1711 20th Avenue | 1715 20th Avenue

Design Review MUP Recommendation Packet | Project #3029632, #3029633 | February 13, 2019

Proposed Access Street View

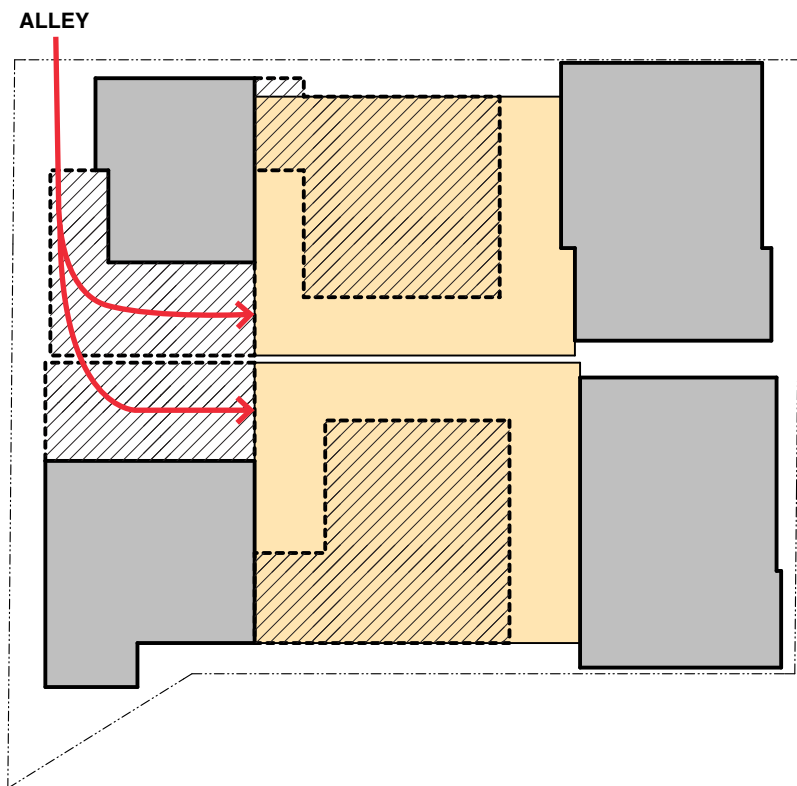
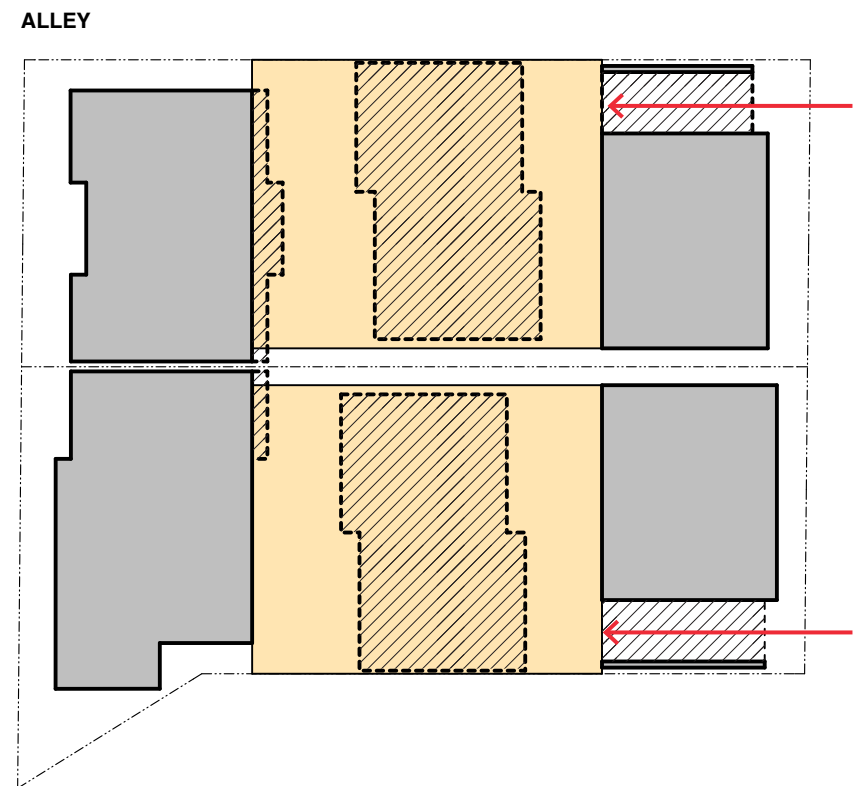
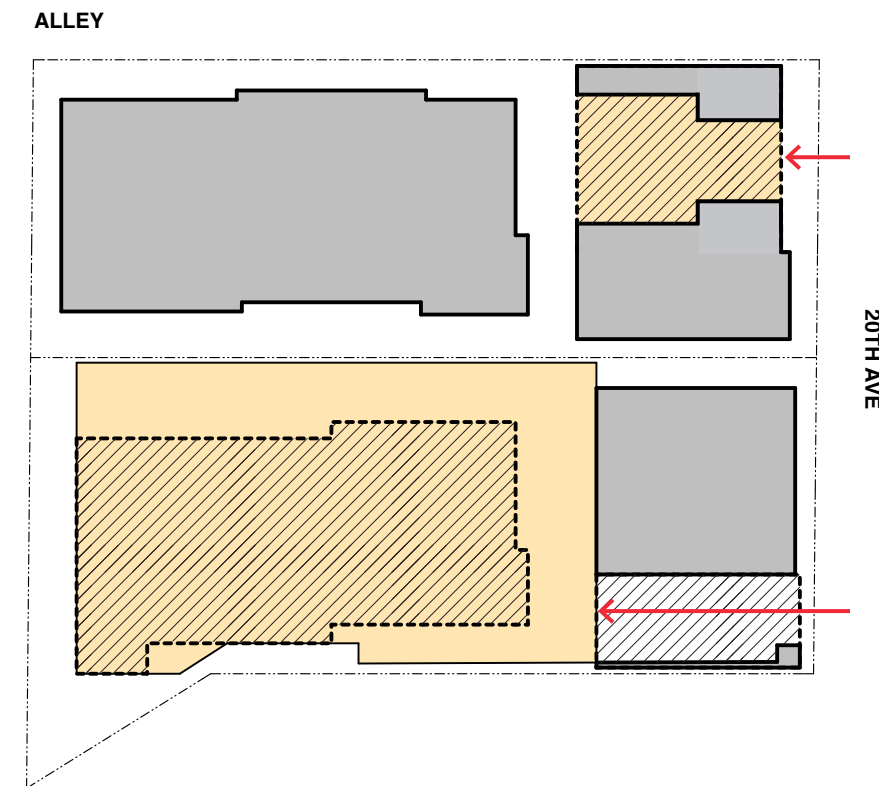
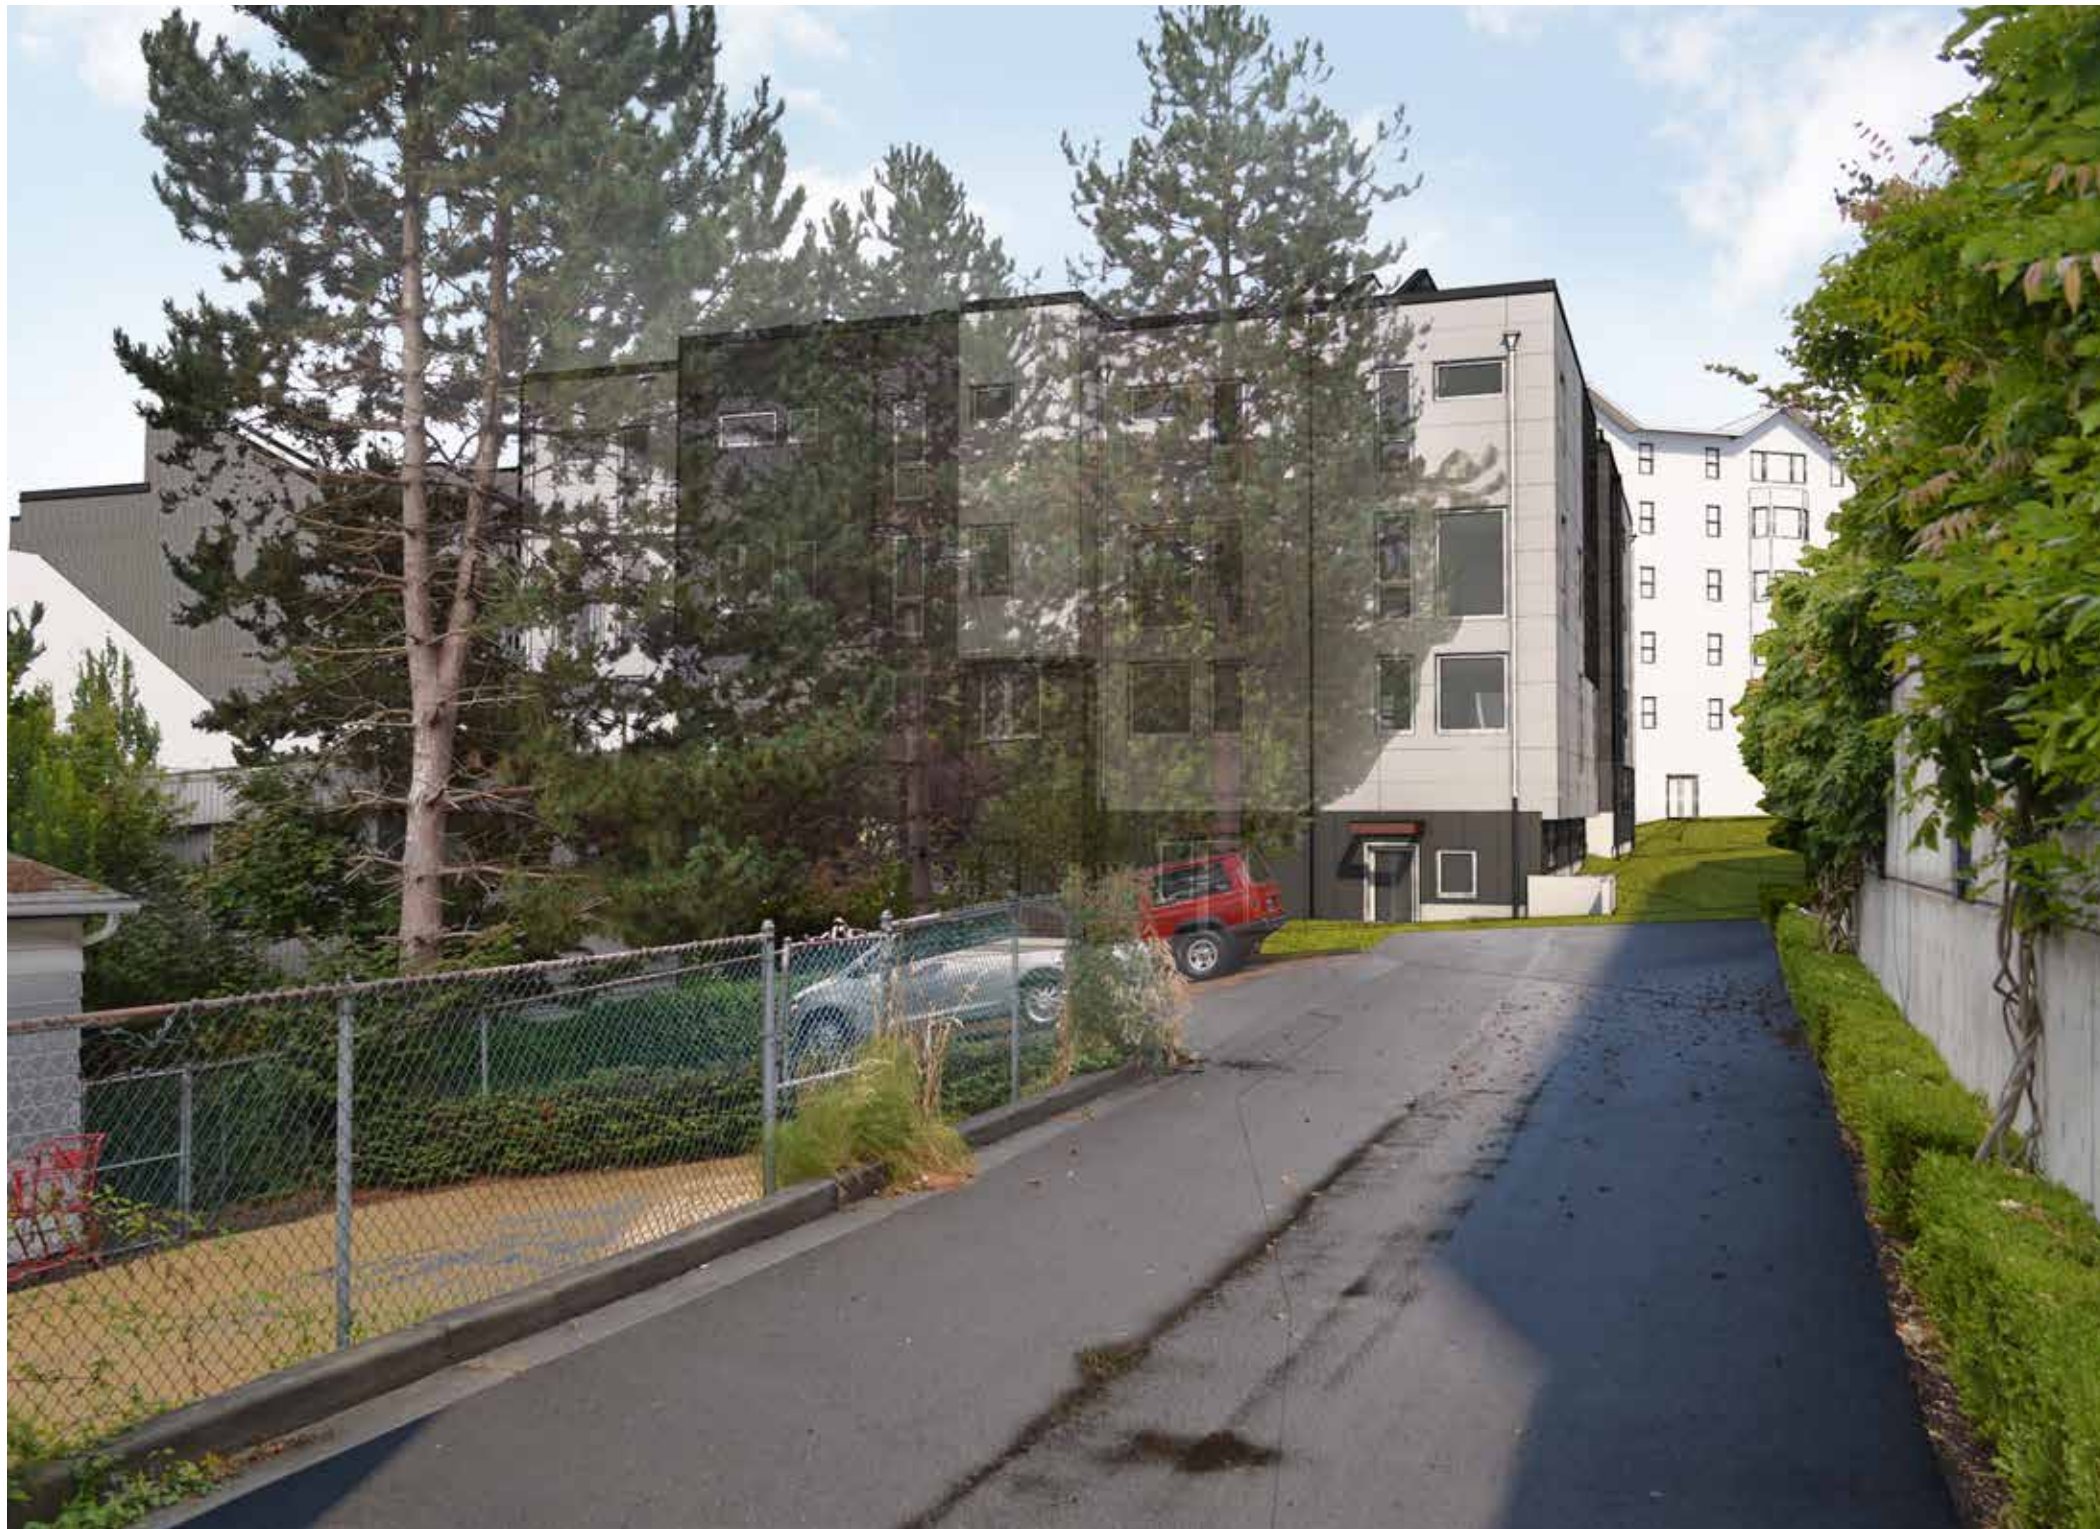
GARAGE ACCESS

- The design proposal has evolved since EDG. All access is now proposed to be from 20th Avenue for pedestrians and vehicles. The project was unable to secure an easement with the adjacent neighbor to allow vehicular access from the rear of the site. As a result, the west edge of the proposal has opened up to receive more afternoon daylight and provide a landscape buffer along the west edge. Parking access is provided at the north and south edges of the development site, with pedestrian access in between to the street-facing units and the courtyard. The driveway to the south of the site provides access to the below grade shared garage which contains the majority of the parking for the proposal. Two parking stalls are accessed beneath two units at the north edge of the site.

(A) Proposal 1 Presented at EDG
Alley Access to shared parking is not feasible without a shared access easement with the site to the west. Topography and specific project needs prevented it from working.

(B) Proposal 2
Shared parking garage on each site, accessed from 20th Avenue

(C) Current Proposal
Larger shared parking on south site, with smaller shared garage on north site.

1 Aerial View looking Northwest

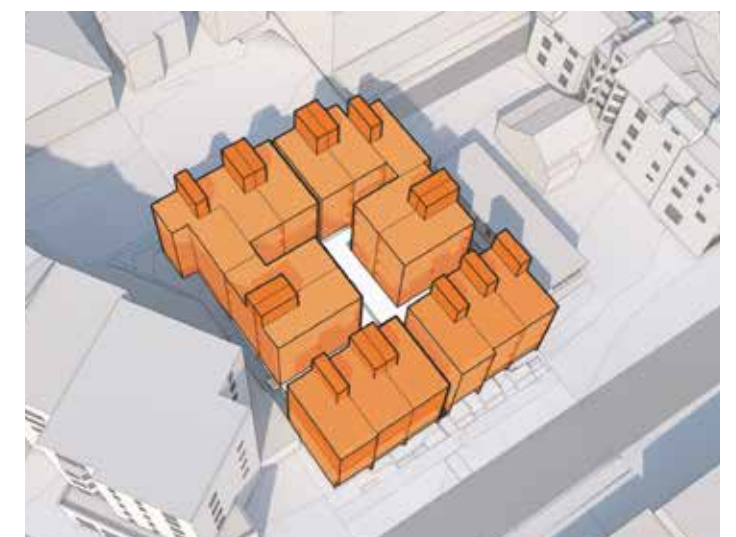
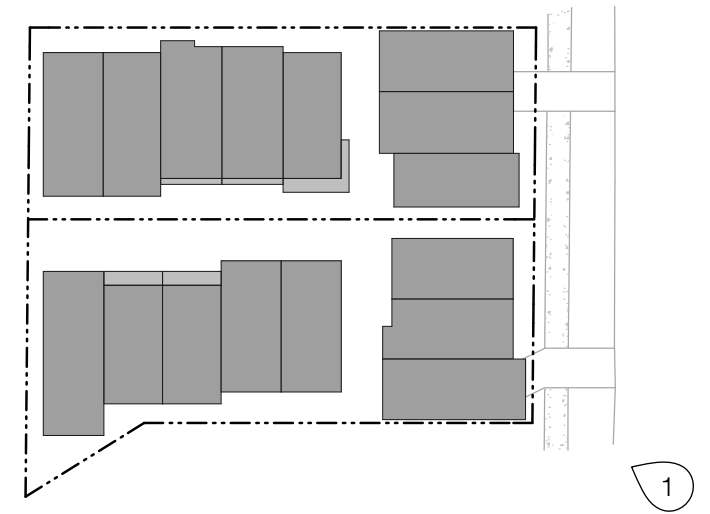
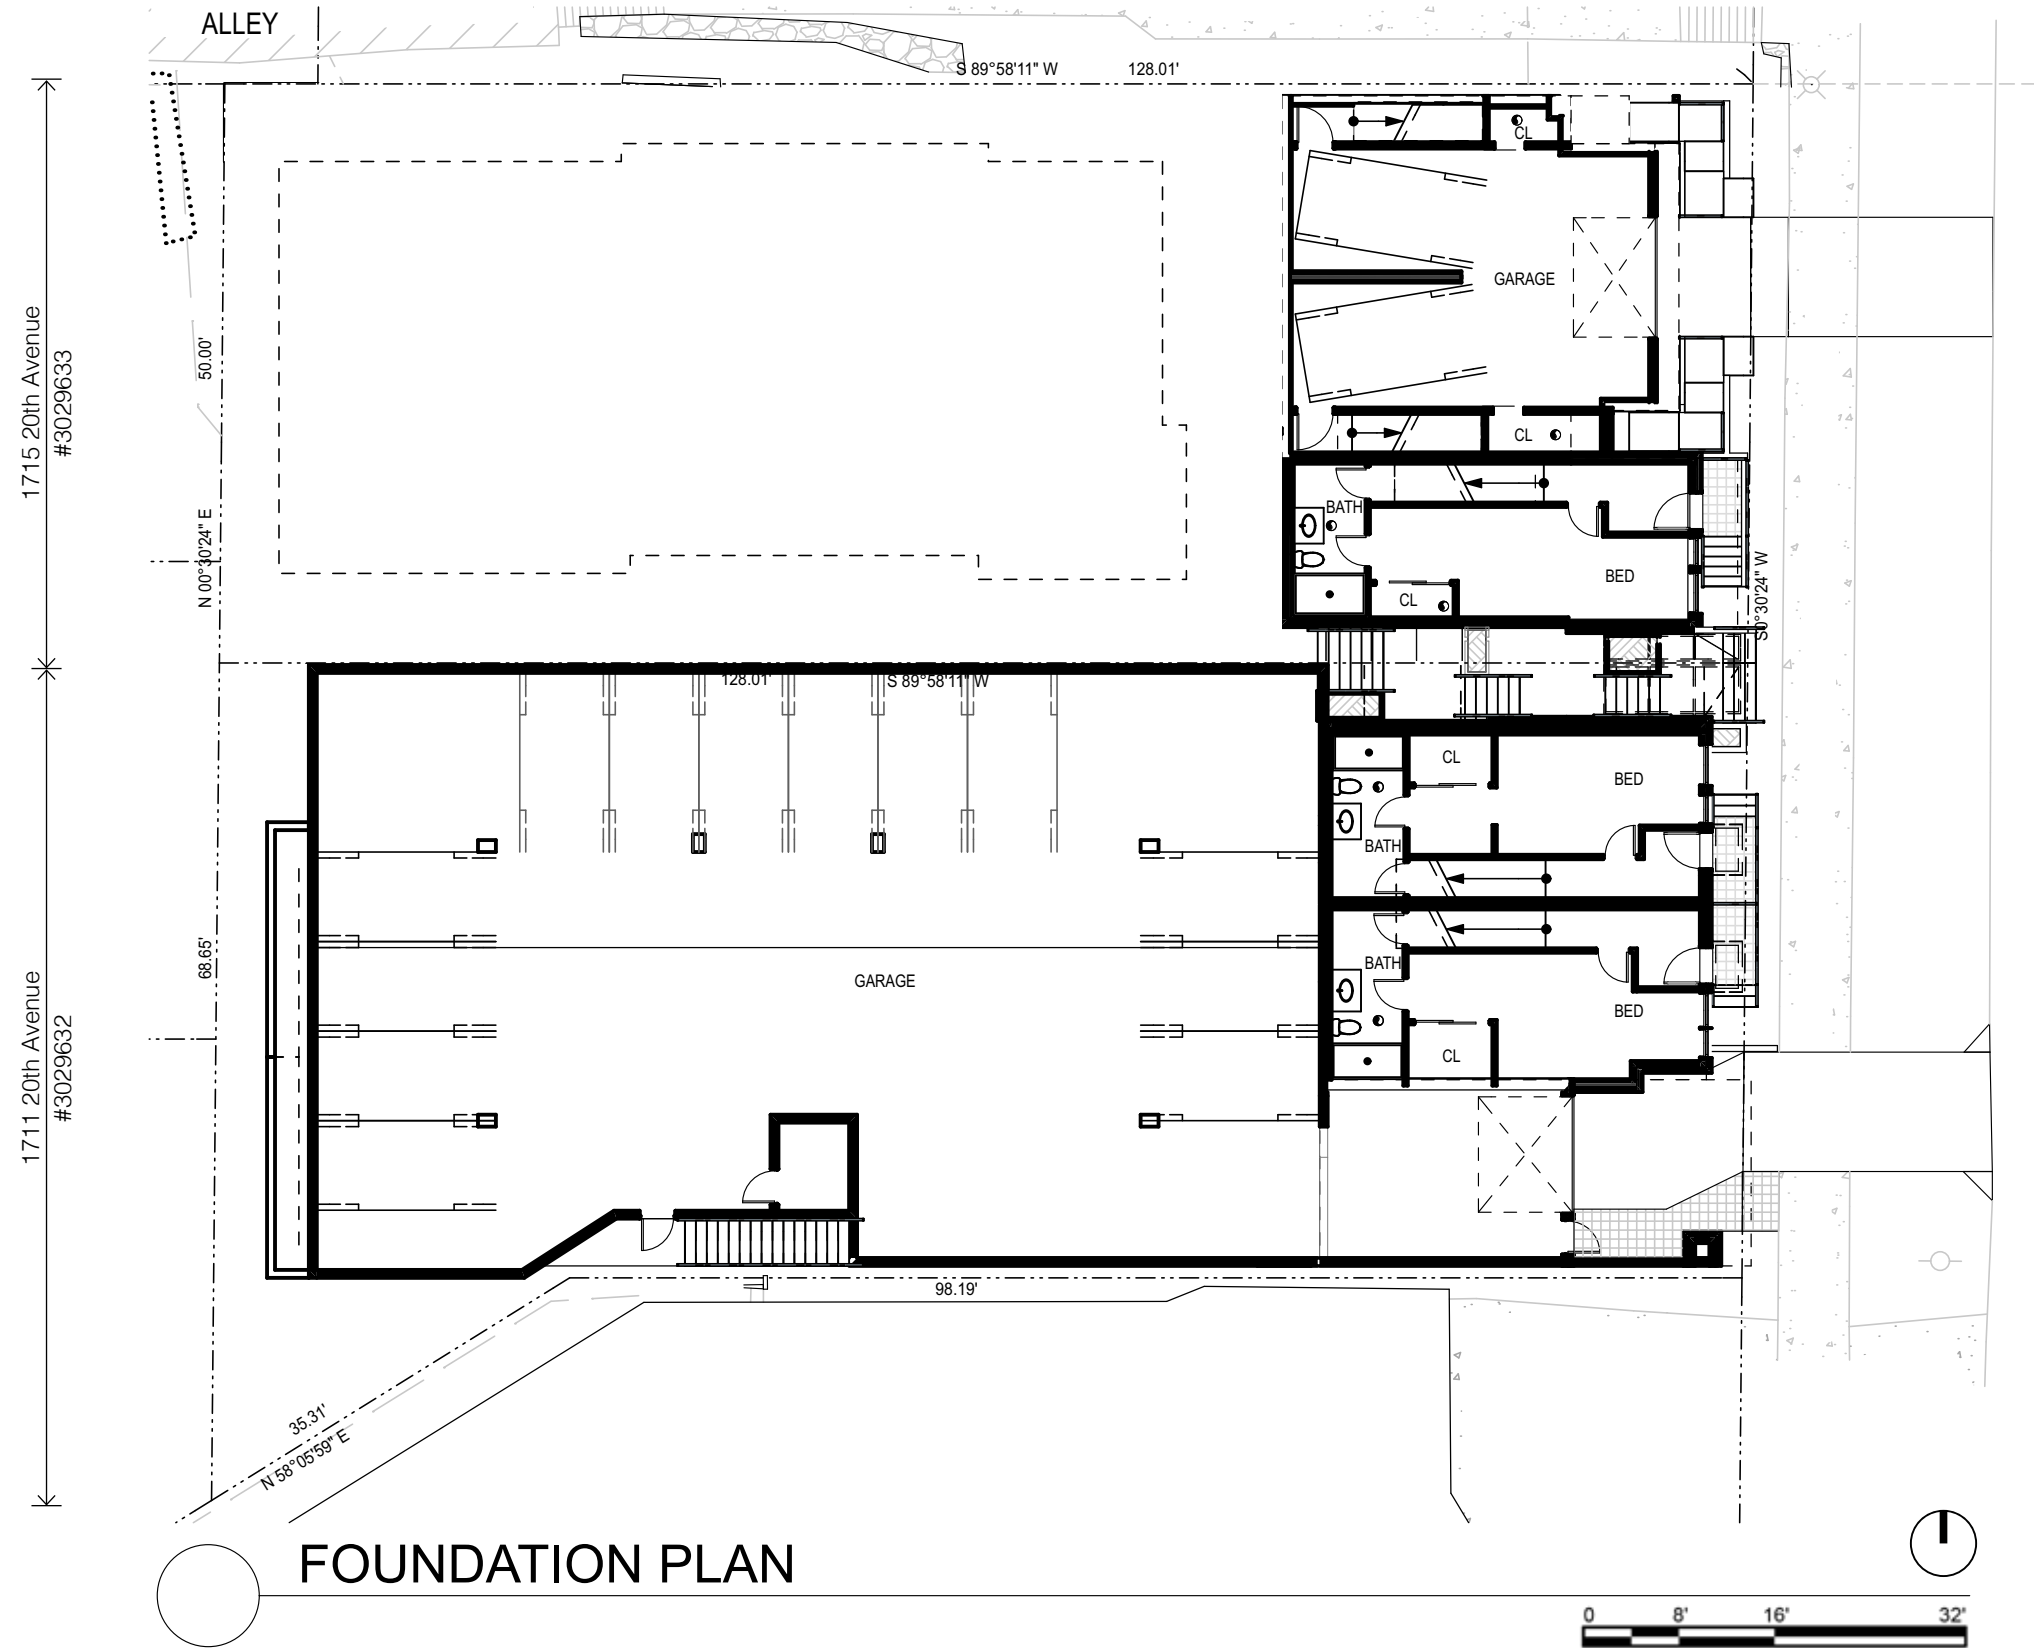
ROOFTOP AMENITY SPACE

- The roof top amenity spaces are all private decks, accessed from individual stairs in each unit. They have been located away from property line edges to minimize impact on neighboring residential uses.
- All private stair penthouses have been chamfered at the top to minimize their overall height, bulk and mass.
